CALIFORNIA COASTAL COMMISSION

**STAFF REPORT: REGULAR CALENDAR
COASTAL DEVELOPMENT PERMIT**

APPLICATION NO.: A-3-SNC-98-114

PROJECT DESCRIPTION: Monterey Bay Shores Resort, a subdivision and development consisting of 495 units of mixed uses; a 217-room hotel, 100-unit Vacation Ownership Resort (timeshare), 45 visitor serving (rental pool) condominium units, and 133 residential units. Each of these facilities will be located on separate parcels created from the existing 39-acre parcel (approximately 32 acres of which are above the mean high tide line) as part of the project. A fifth parcel comprising the remaining 16.6 acres of the site (7 acres of which are below the mean high tide line) is proposed along the shoreline. Ancillary facilities include a restaurant/bar, conference center, tennis courts, pool, spa, and private recreation areas. The project also includes public access trails and a public recreation area, as well as 10.2 acres of restored and stabilized sand dune habitat.

PHOTO POINT 2: Southbound 1,330 Feet North of Property Line

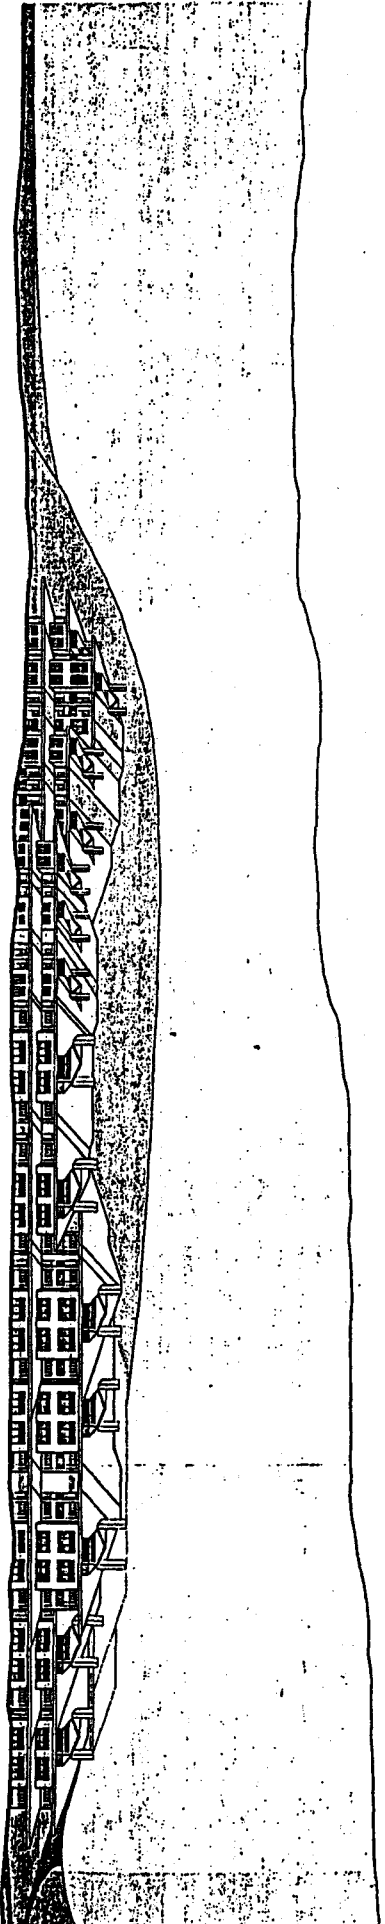
Northern portion of these buildings must be lowered by one story per City Council's approval.

ALTERNATIVE C HOTEL AND VOR BUILDINGS - VIEW PERPENDICULAR TO SHORELINE FROM BEACH

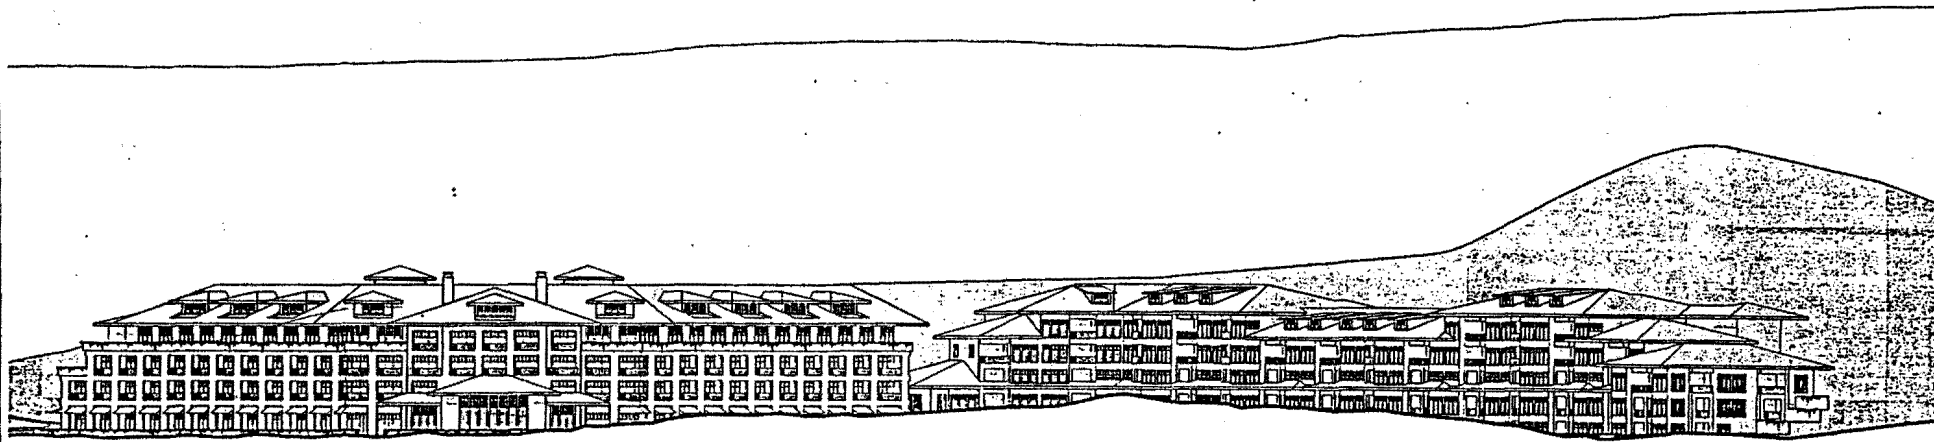
Hotel building lowered by 10 feet in elevation
VOR building lowered by one story
per City Council's approval

EXHIBIT NO. 21
 APPLICATION NO.
 A-3-SNC-98-114
 Fig. 2 of Update
 Geotechnical Report
 California Coastal Commission

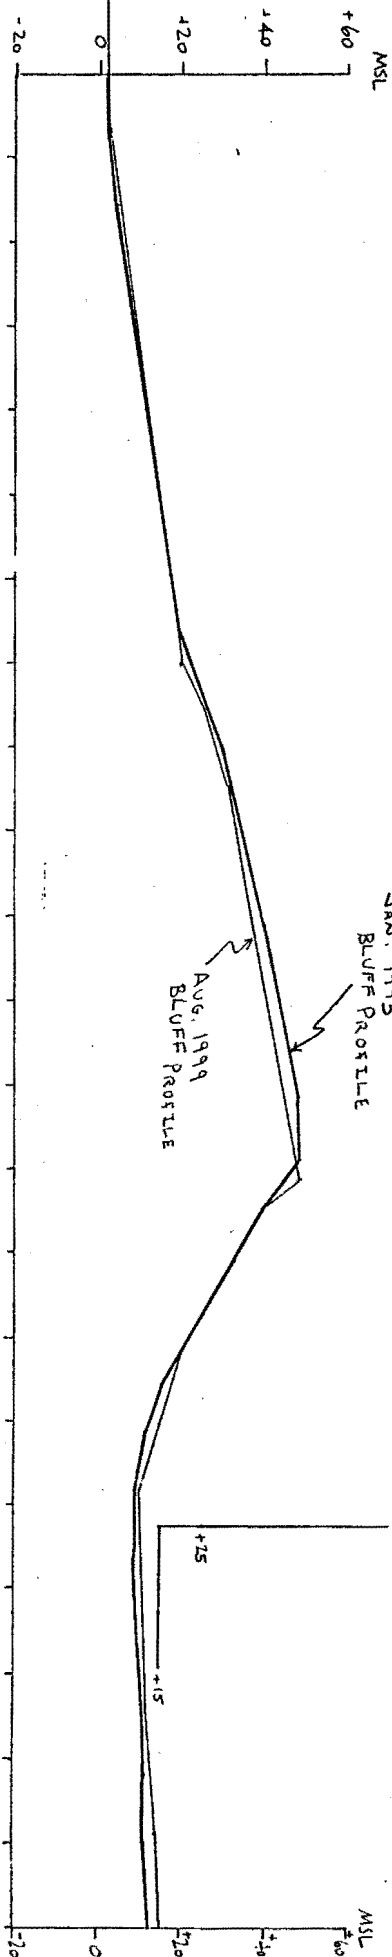
The results of these two profiles are presented in Figure 2, Appendix A of this report [please see Exhibit 21]. A comparison of the two beach and bluff profiles shows that the mean high water line has virtually remained stationary, indicating that the nearshore, foreshore and backshore of the beach has not eroded landward nor scoured in depth for a 5 year, site specific, measurement period. A comparison of the coastal bluff crest from 1995 to 1999 indicates that the crest has moved landward approximately 5 ½ feet. Some small areas of the escarpment have moved landward 4 feet. The wind blown sand from this escarpment appears to be depositing itself in the open hole according to the profile comparison, which is expected and natural, for the windward and lee slopes of a transverse dune. The two areas of measurable recession in our profile comparison equate to erosion rates of about 1.5 feet per year. Realize that the two measurements were taken before and after a significant El Nino winter storm season (1998) which should maximize coastal erosion. Comparison of this measured erosion rate with the Moffat and Nichol low risk recession rate of 3.5 feet per year indicates that erosion at the site, even with the occurrence of an El Nino winter storm season, is not as rapid as used in design of the setback lines for the proposed buildings. The 1.5 feet per year of erosion since 1995 more closely matches the high risk recession of 102 feet in 50 years presented by Moffat and Nichol (2.0 feet per year).

The project site, as shown in Figures 2 and 3 of the Update Geotechnical Engineering Report (please see Exhibits 21 and 22), has a broad beach that is approximately 140 feet wide and gently slopes up to an elevation of approximately 20 feet above Mean Sea Level (MSL). At this point, the beach transitions to a dune form, which steeply rises to elevations ranging between 35 feet to over 60 feet above MSL. The base of the dune form, as shown by Figure 3 (Exhibit 22) of the Update Geotechnical Engineering Report, is steeper than the more landward portions of the dune, likely as a result of wind and wave erosion. This steep section of dune is considered the "dune scarp".

PROJECT NO:	M5613	1999 DUNE PROFILE WITH SETBACK LINES MONTEREY BAY SHORES MONTEREY COUNTY, CALIFORNIA
DATE:	9/30/99	
SCALE:	1" = 30', H=V	
DRAWN BY:	JT	
HARO, KASUNICH & ASSOCIATES

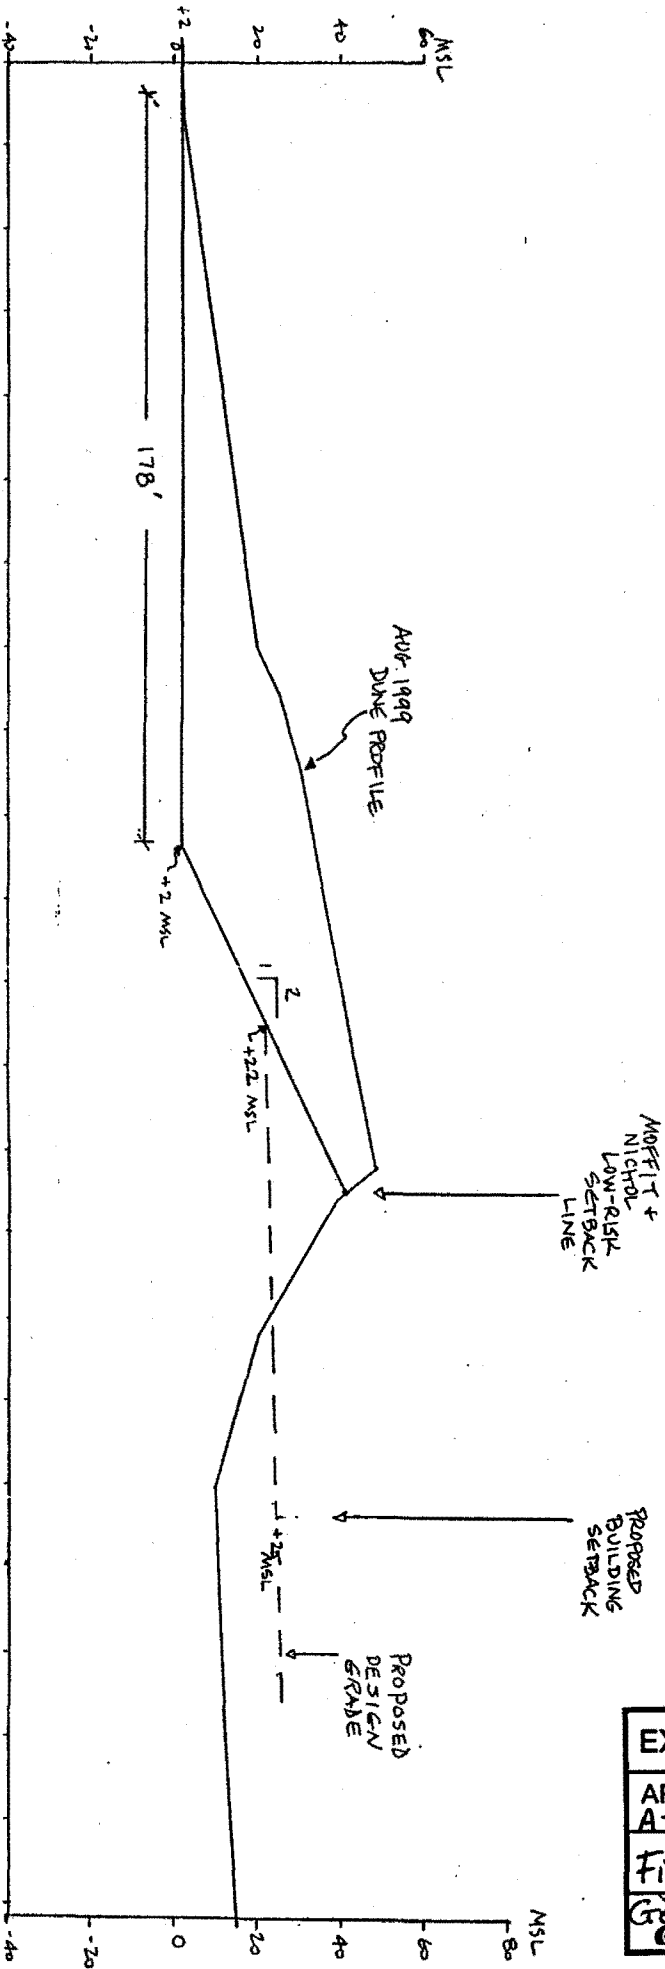
Run-Up Analysis: The design parameters for the wave run-up analysis contained in the Update Geotechnical Engineering Report assumes a 2:1 coastal bluff on site. This is not consistent with the bluff slopes that will exist after project construction. Thus, the run-up analysis needs to be recalculated to reflect the actual dune slope that will exist after project construction. In addition, several of the model runs for El Niño conditions, using the 2:1 slope, show run-up elevations in excess of 30 or even 35' MSL, yet the report proposed to use a value of +30' MSL. There are many possible reasons for excluding these more extreme run-up conditions for design purposes, but the report did not provide any explanation. The revised run-up analysis should clearly identify the design storm conditions and make clear why any extreme condition analyses of run-up are not being considered in the development of storm wave run-up for the design conditions.
